22 January, 2015

Our Reference: 0226308L01 RESPONSE TO ADDITIONAL SUBMISSION.DOCX

**RE: KINGS PARK WASTE METAL RECYCLING FACILITY (SSD 5041)-
RESPONSE TO ADDITIONAL COMMUNITY SUBMISSION**

Figure 3: Dust deposited on the Pick 'N Payless (June 2010 photos)

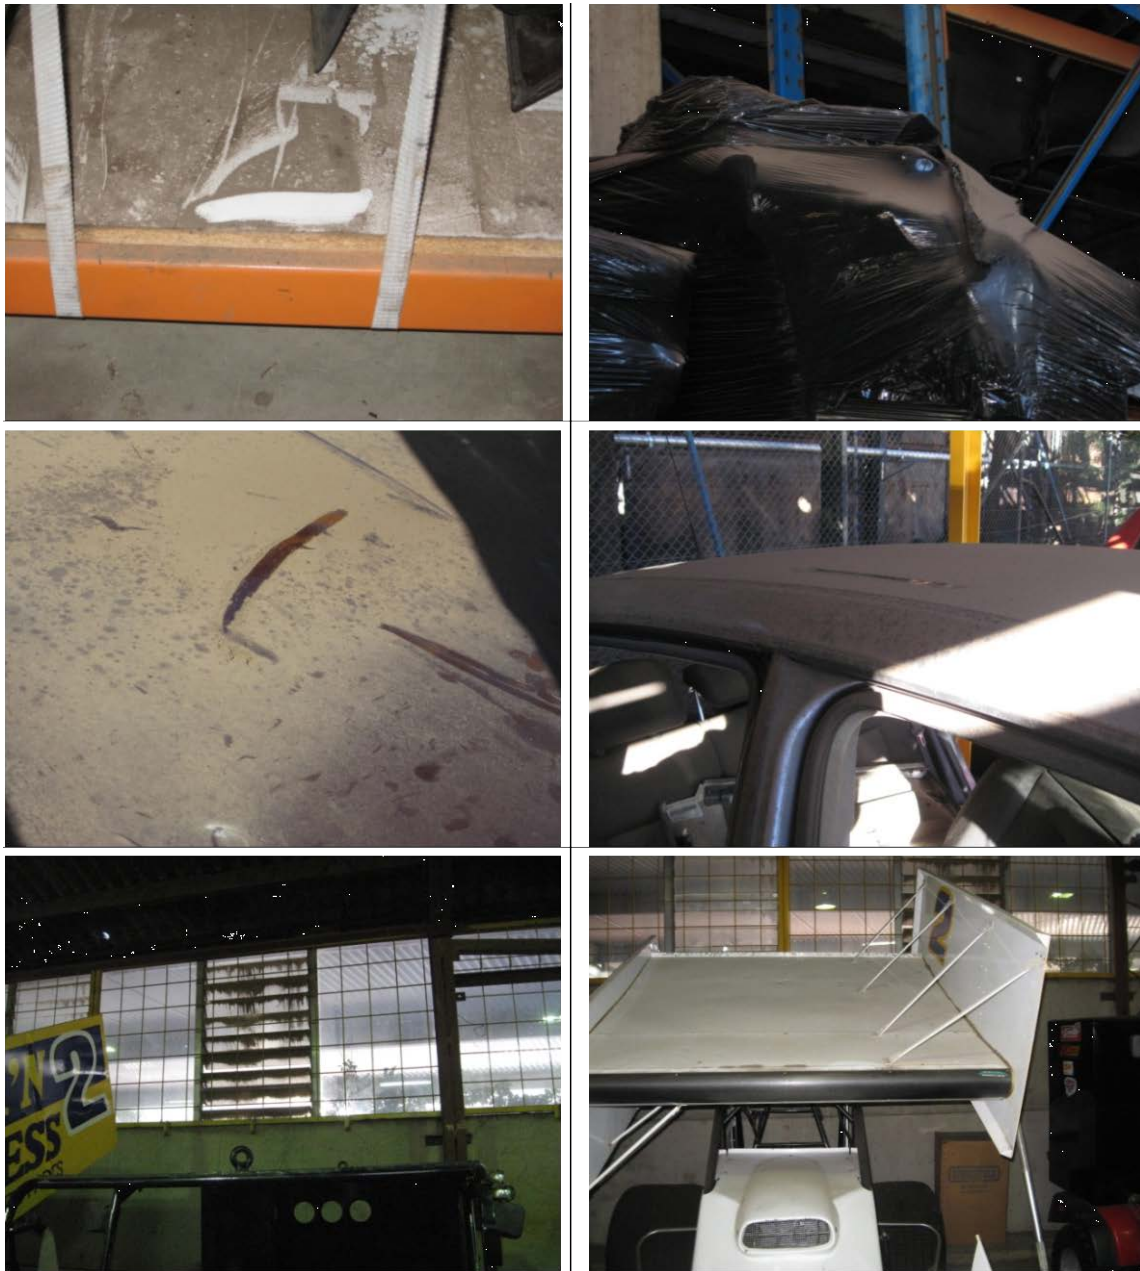
Illustrations of dust deposition within the PNP site (see Figure 3) suggest that conditions related to air quality have not been fully complied with. Stephenson Environmental Management Australia (SEMA) prepared an expert report for PNP that demonstrated exceedance of dust deposition from the Facility. SEMA conducted dust deposition monitoring at PNP during two consecutive one-month periods between 14 March to 16 April 2003, and 16 April to 16 May 2003 (dry weather month and wet weather month). Their report concluded that:

- *The deposited dust levels measured during the monitoring period 14 March to 16 April 2003 were well above the NSW EPA ambient air quality goal and Development Consent Condition 115 at monitoring locations L1 and L2 on the eastern boundary of the Pick 'N Payless site which forms a common boundary with the metal recycling facility. (Note: prevailing wind from the east during this monitoring period).*
- *The concentrations of deposited dust measured during the monitoring period 16 April to 16 May 2003 during wet atmospheric conditions mostly from the south were still above the EPA*

ambient air quality goal. (Note: prevailing wind varying from south-east and south-west in this monitoring period).

all sensitive receptor locations. These are summarised in Section 7 of the revised air quality assessment prepared by ERM (2014) and provided in *Annex C*. ERM has revised the modelling to account for mitigation of dust emissions from materials handling, receipt of materials and stockpiles through the use of water sprays. With the implementation of these controls, the mean annual dust concentration was modelled below the relevant assessment criteria at all sensitive receptor locations.

The revised air quality assessment prepared by ERM (2014) is provided in *Annex C*. Further, the response provided to the EPA in relation to the air quality issues raised is provided in *Annex D*. The information provided in the PNP submission in respect to deposited dust, is sourced from an out of date and largely irrelevant 2003 report carried out by SEMA. The proposed activities will differ from that previously and currently being undertaken on-site, and it is the new development proposal that must be assessed, not that being undertaken now or historically.
